UNITED STATES PATENT AND TRADEMARK OFFICE

10/840,195

Office Action Summary	Application No. 10/840,195	Applicant(s) ABOUL-HOSN, WALID NAJIB	
	Examiner JULIE A. SZPIRA	Art Unit 3731

DETAILED ACTION

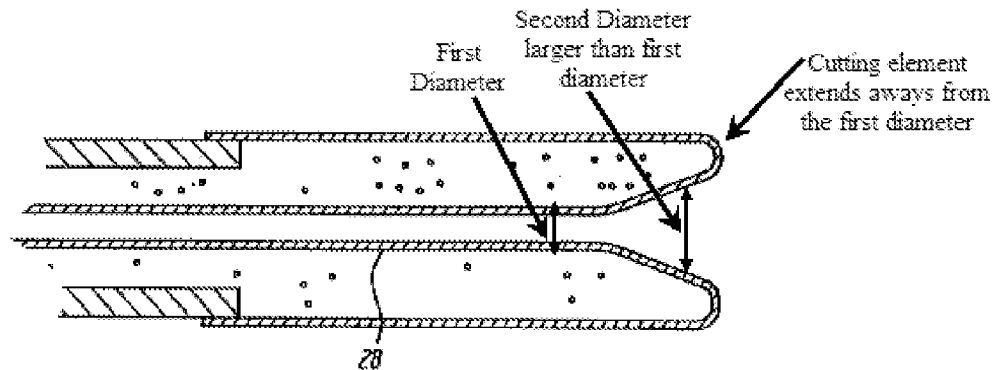
Regarding claim 39, Mollenauer discloses a system for harvesting a length of a vessel from a patient, comprising: an elongated element having an interior dimensioned to be advanced over a length of autologous vessel (25); and

a cutting element (balloon dissector) disposed at a distal end of said elongated element, said cutting element configured to extricate the exterior of said length of a vessel from surrounding tissue (Figure 8a; column 6, lines 35-42).
